## **Important Notices**

**TOSHIBA Microcontrollers TLCS-870 Family**  
**TLCS-870/C1 Series**

## Restrictions on the Voltage Detection Circuit

## Datasheet Corrections regarding the 16-Bit Timer Counter

#### Pulse width measurement mode

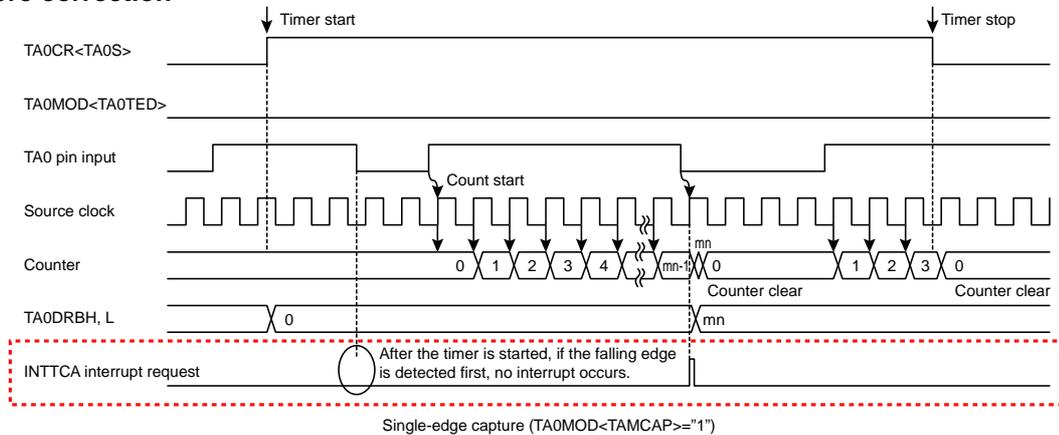
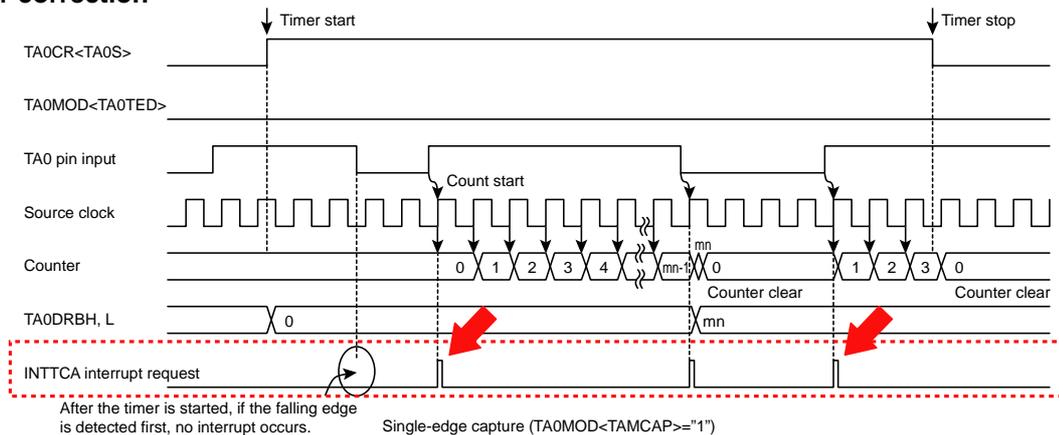
1. The timing diagram for single-edge capture indicates that no interrupt request occurs at the first count start edge and the second count start edge after the timer is started. This should be corrected so that an interrupt request occurs at the first count start edge and the second count start edge, as shown below.

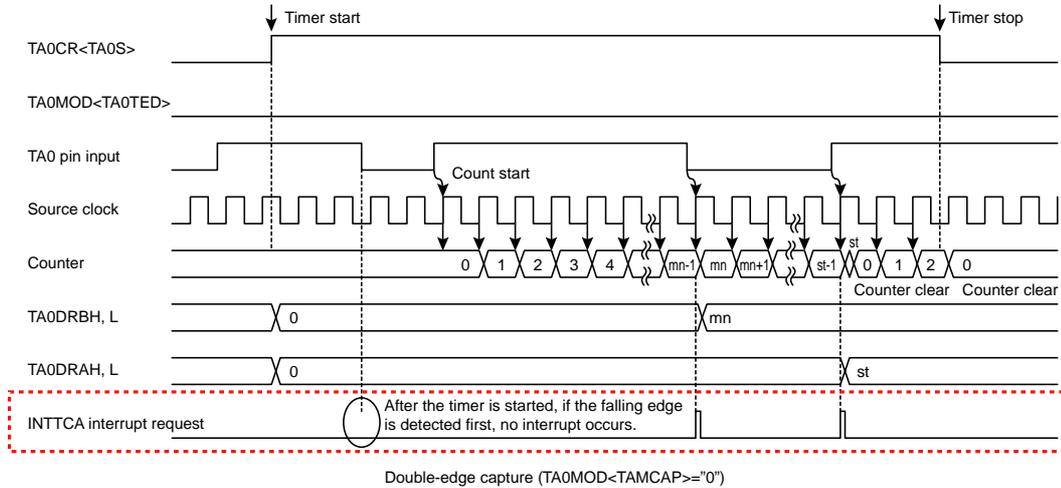
- The timing diagram for double-edge capture indicates that no interrupt request occurs at the count start edge after the timer is started. This should be corrected so that an interrupt request occurs at the count start edge, as shown below.
